Access Compliance Report

Public Rights-of-Way

(Curb Ramps)

Intersection ID: 49802	Main Street: ATKINS RIDGE DR	Cross Street: GANDOLFO CT	Location: W
ADA ID: A73D90ACE7E3	Ramp Type: Perp	Initial Pass/Fail: Fail	Overall Compliance: No
Severity Score: 12.5			
Codes/Mitigation Info/Possible Solution		Field Measurements/Component Compliance

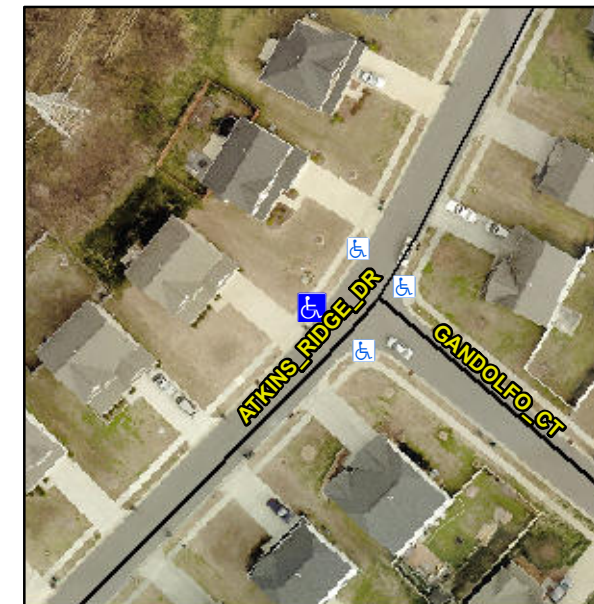
Not Found, R304.5.3

Compliance	Description	Data	Compliance	Description	Data
N/A	Ramp Length (in)	47.0	Yes	Ramp Slope (%)	6.0
Yes	Ramp Width (in)	48.0	No	Ramp XSlope (%)	5.5
N/A	Flare Type LT	N/A	N/A	Flare Type RT	N/A
N/A	Flare Slope LT (%)	N/A	N/A	Flare Slope RT (%)	N/A
N/A	Flare Traversable LT?	N/A	N/A	Flare Traversable RT?	N/A
N/A	Landing Length (in)	N/A	N/A	DWS Provided?	N/A
N/A	Landing Width (in)	N/A	N/A	DWS Contrast?	N/A
N/A	Landing Slope (%)	N/A	N/A	DWS Length (in)	N/A
N/A	Landing X Slope (%)	N/A	N/A	DWS Full Width?	N/A
N/A	Landing Curb? (Y/N)	N/A	N/A	DWS Offset (in)	N/A
N/A	Shared Landing?	N/A			
N/A	Gutter Ponding?	N/A	N/A	Gutter Slope (%)	N/A
N/A	Gutter Lip Ht (in)	N/A	N/A	Gutter X Slope (%)	N/A
N/A	Painted X Walk1?	No	N/A	Painted X Walk2?	N/A
	X Walk 1 Direction	To SE		X Walk 2 Direction	N/A
N/A	X Walk 1 Width (in)	N/A	N/A	X Walk 2 Width (in)	N/A
	X Walk 1 Slope (%)	2.1		X Walk 2 Slope (%)	N/A
	X Walk 1 X Slope (%)	5.8		X Walk 2 X Slope (%)	N/A

Remove & Replace Entire Ramp.
